SERVICE DIRECTIVE BULLETIN NO. 0056

Subject: Replacement of Pitch Link Retainer and Service Improvement of the Pitch

Models: F-28C and 280C

FIGURE I

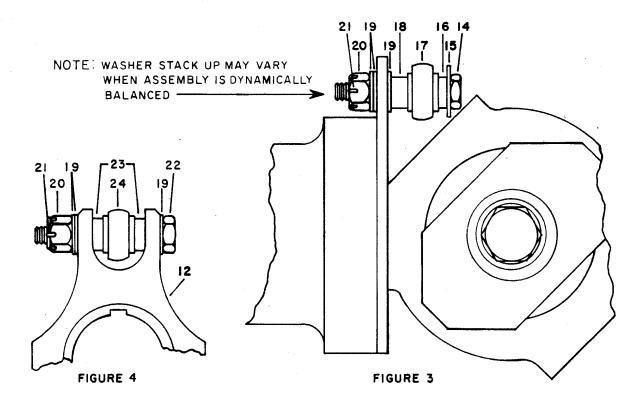
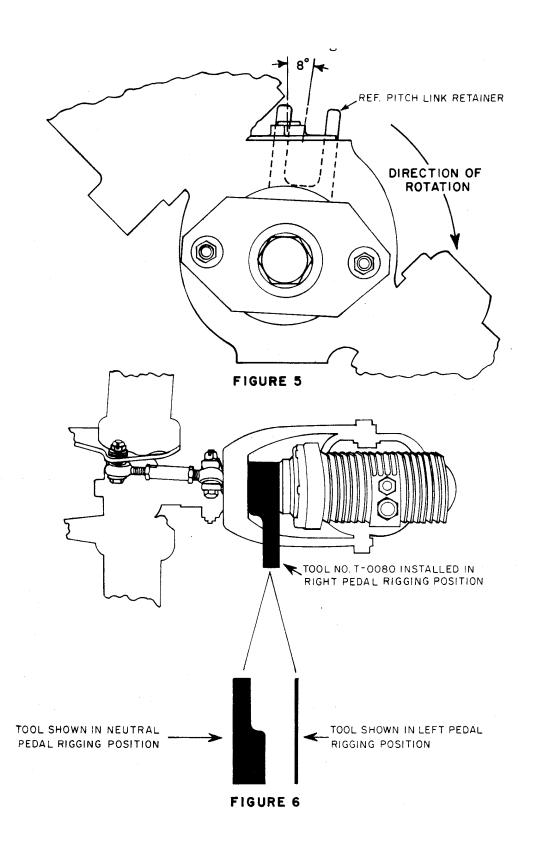
The pitch link retainer has been redesigned to eliminate this stud and its dependence on torque for structural integrity. Additionally, the pitch control system has been redesigned to significantly improve its wear characteristics which will lower the operating cost of this system.

- 2. Assembly (Ref. Fig. 1)
  - a. Press pitch control bearing (5) into bearing (8) and bearing housing (7).
  - b. Install two wave spring washers (10) on bearing (5).

- c. Align dowel pin holes on pitch link retainer (12) with holes in bearing (5) and press retainer on bearing with flat side outboard.
  - d. Support bearing (5) and press dowel pins (11) to depth of .10 inch below surface of pitch link retainer (12).

- e. Install cotter pins (13).
  - f. Install seal (4) in groove on I. D. of outboard end of bearing (5).

- a. Slide seal retainer (3) and seal (4) on spacer (2) to a position inboard of spacer slots.
- b. Install keys (1) into slots of spacer (2).
- c. Align pitch control bearing (5) keyways with keys (1) and install pitch control assembly on spacer (2).
- d. Attach bearing housing (7) to control brackets by inserting the 28-16310-2 bolt through bushing (6) in bearing housing (7), 2 8-16308-1 washer, control bracket, AN 960-516 washers (as required) and secure with F12-NE4717-054 nut and AN381-2-l0 cotter pin.

- e. install seal (4) into retainer (3).
- f. Apply a small amount of Loctite Super Bonder 495 or Eastman 910 to outside diameter of retainer (3) and install retainer in recessed area of pitch control bearing (5).
- g. Install tail rotor assembly (Ref. page 5).
